**ADDENDUM #1**  
INVITATION FOR BID #25-29

**IMPROVEMENTS TO ALBEMARLE PLAYGROUND PHASE I**

**ADDENDUM NO. 1**

**IFB #25-29**

FINISH:			<b>ERP Part #: GD-CUSTOM</b>		
DRAWN BY			TITLE: Custom Gameshade With Closet		
REVISED BY			SIZE	DWG. NO.	REV
SPORTSFIELD SPECIALTIES INC.			<b>B</b>	<b>121974</b>	<b>A</b>
SCALE: 1:64			DO NOT SCALE DRAWING	WEIGHT: 1367.283	SHEET 1 OF 7

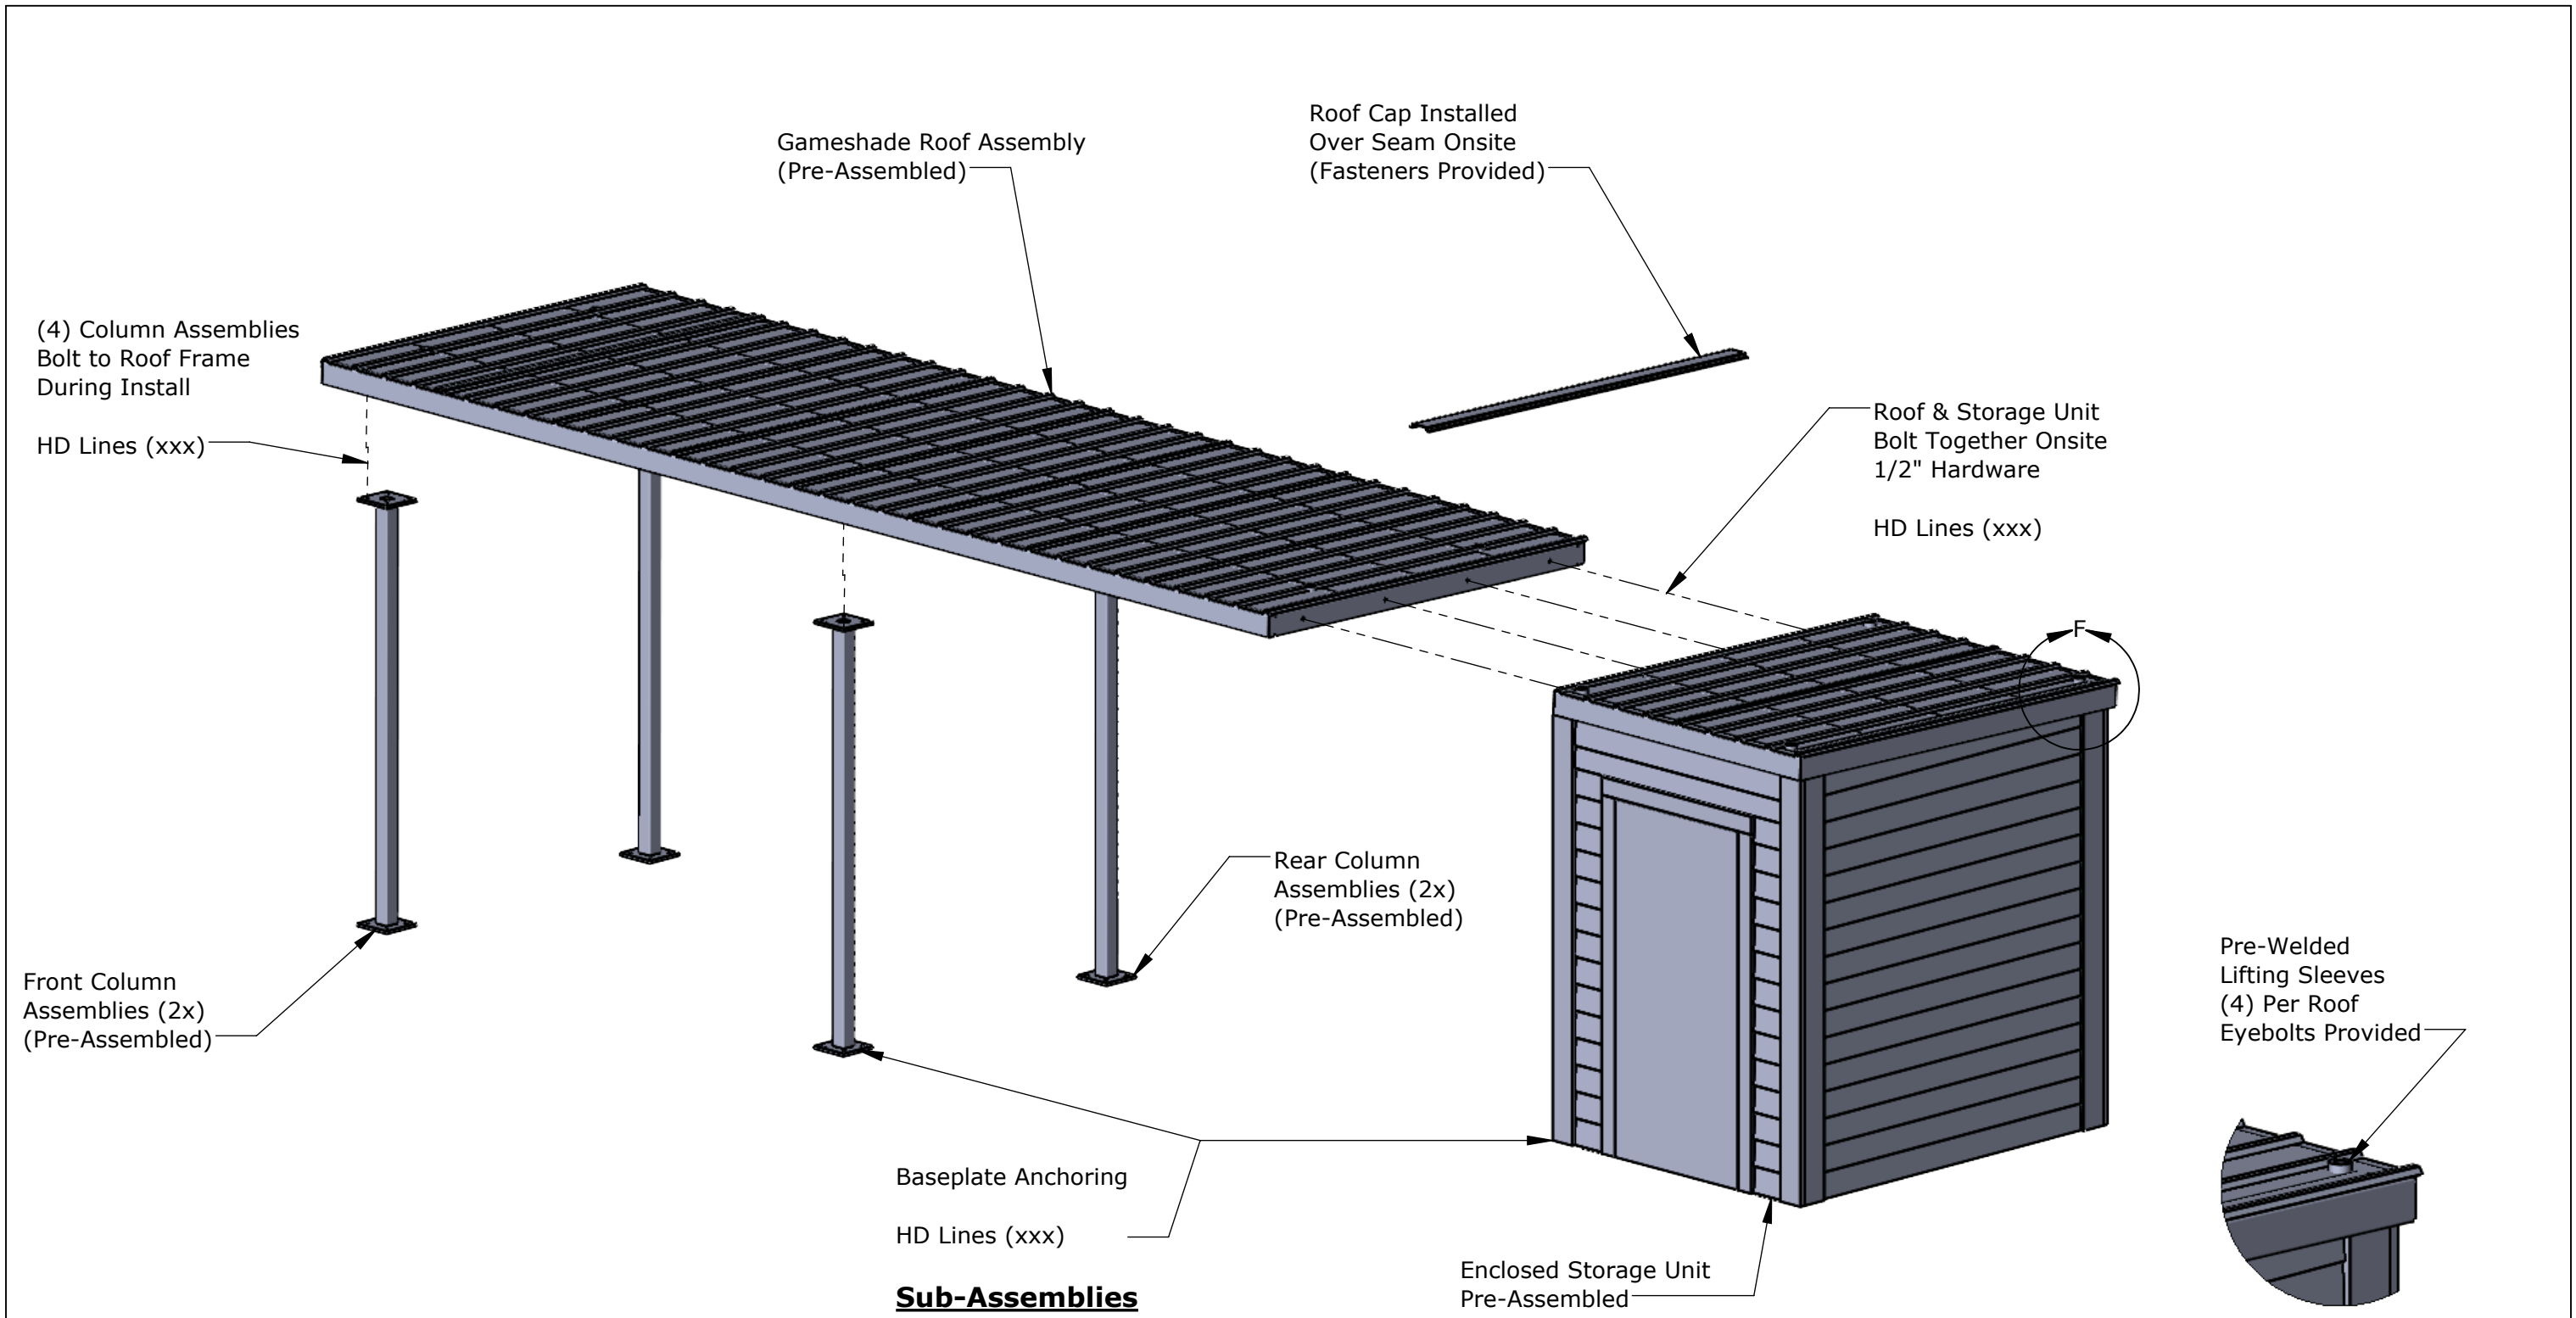
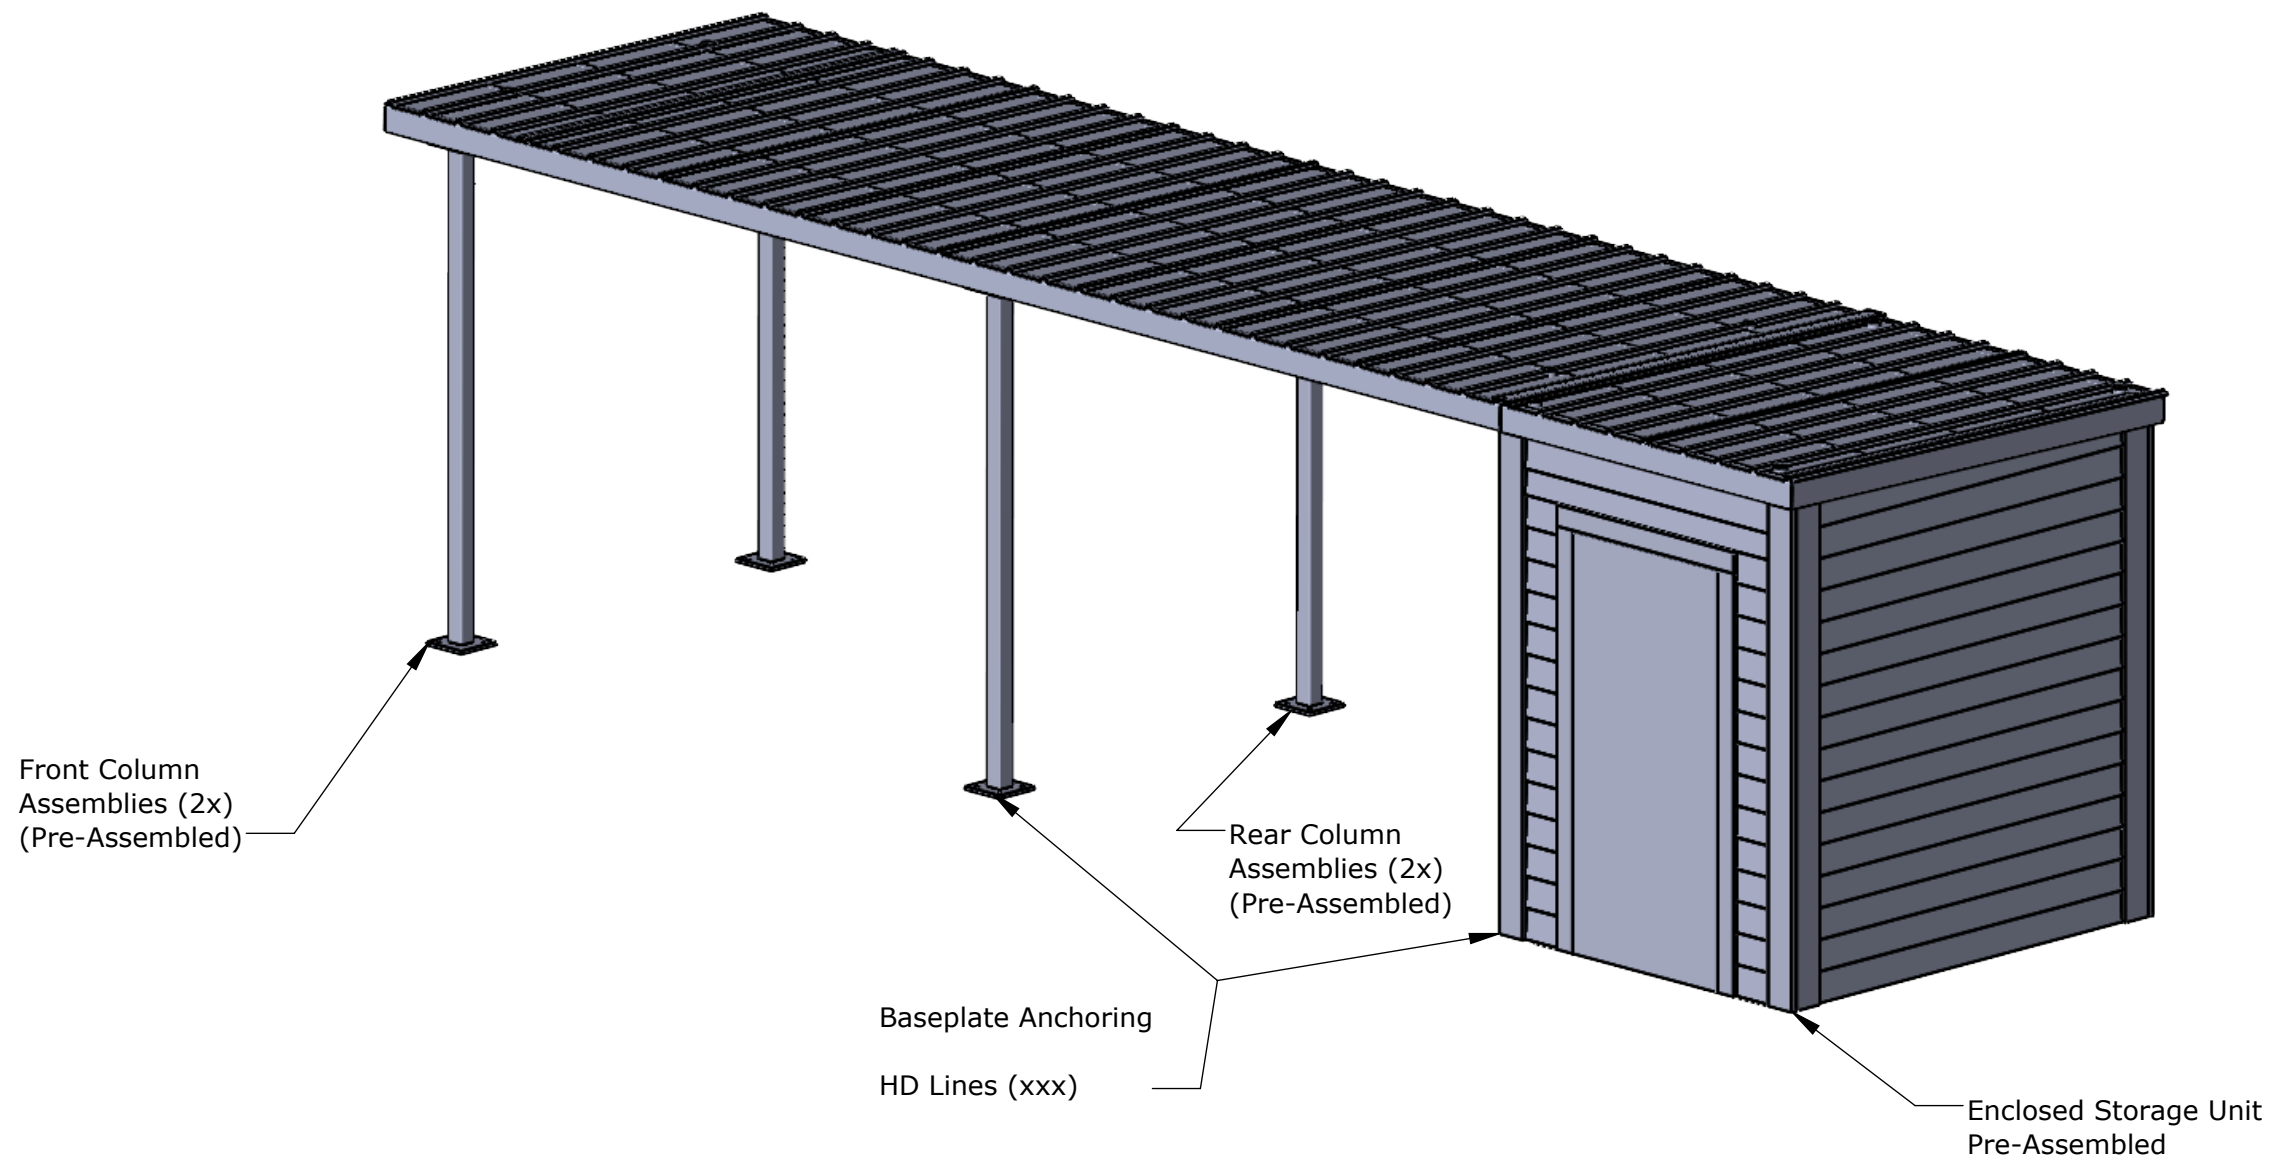
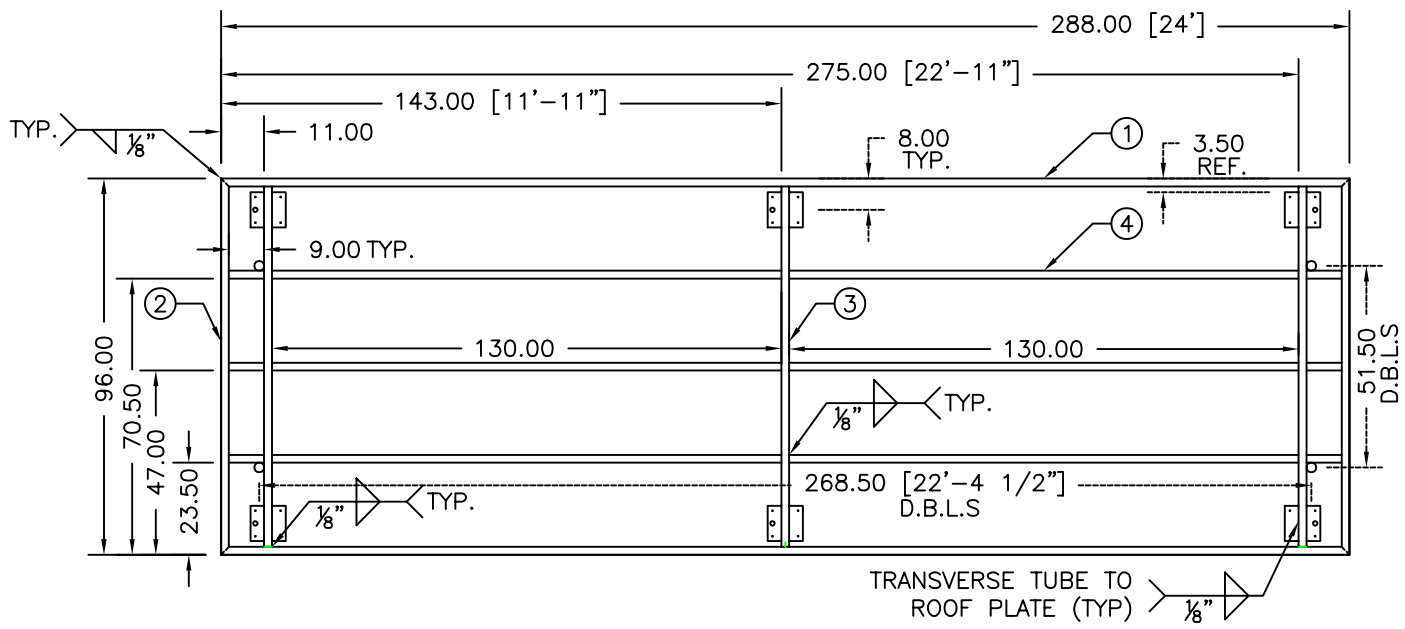
6. The electrical wall penetration at the existing building has been clarified with an added detail. See detail 6 on the revised sheet E900 in the attachments to this addendum.
7. Detail 1 on sheet L705 has been revised and included along with cut sheets on the dugout shelter with (and without) the storage unit as an attachment to this addendum.
8. Groundwater test results have been included as an attachment to this addendum.
